Re: Grassy Pond Place  
DEP 085-0965  
6673W161

Re: Grassy Pond Place  
6673W161

We are in the process of finalizing the retaining wall design for the shared driveway at Grassy Pond Place. This driveway provides access to one existing and three recently permitted homes. During our review of the drawing dated April 30, 2007 prepared by Stamski & McNary Inc. we found a conflict in the drainage design within the limits of this wall.

PIPES INTERSECT 1" = 20'

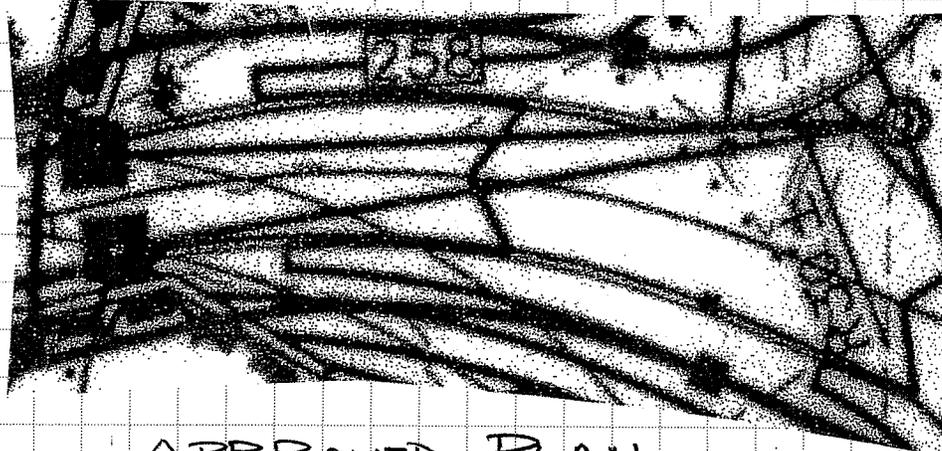
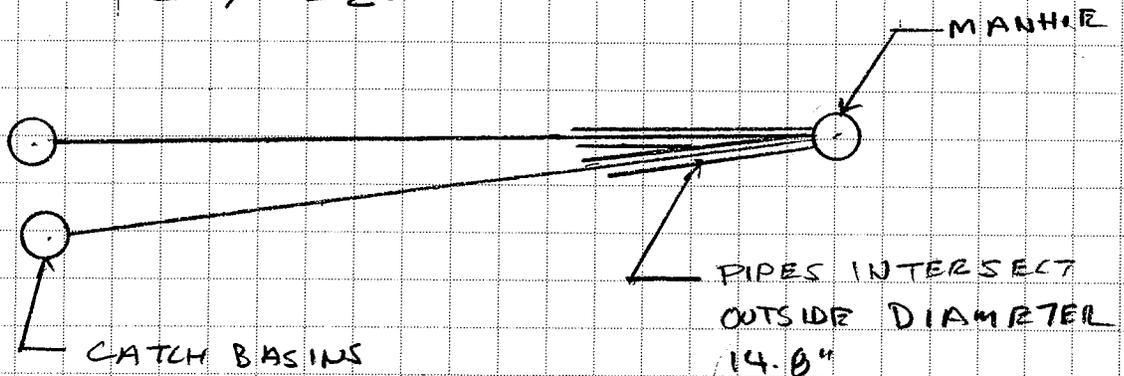
The current design calls for two catch basin at the low point of the drive with discharge pipes connecting to the diversion manhole located 80 feet to their northeast. As designed, the outlet pipes meet at the same invert elevation and with an acute angle of only 7°. Given these dimensions the two pipes cannot physically enter the manhole and intercept each other approximately 10 feet outside the manhole as illustrated on the attached drawings.

With a driveway width of 12 feet we believe that the driveway can be adequately served by one double grated catch basin at the center of the driveway.

ROAD CROSS-SECTION 1" = 20'

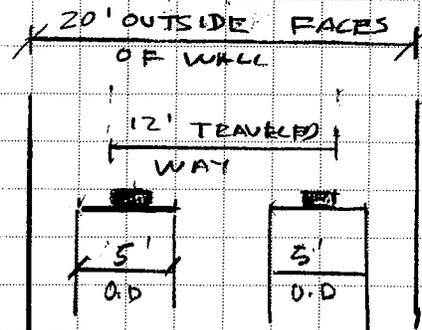
The driveway passes between two bordering vegetated wetlands and wall footings cannot extend beyond the outer limits of the wall resulting in either the footings required for a cast in place wall extending below the road or the utilization of five foot deep precast concrete units. Either the retaining wall footings or precast units would extend into the area of the catch basins.

A single 24 inch reinforced concrete culvert is proposed under the driveway to replace the existing 8 inch cross drain.

The precast concrete blocks have a height of 16 inches and we recommend that the single 24 inch pipe be replaced with three 12 inch smooth interior high density polyethylene pipes. This would allow the pipes to fit with one course of the wall so that integrity of the wall will not be compromised.

As an alternative we have asked the wall manufacturer to determine if a 3'WX1'H inside dimension box culvert could be fabricated as a possible substitution.
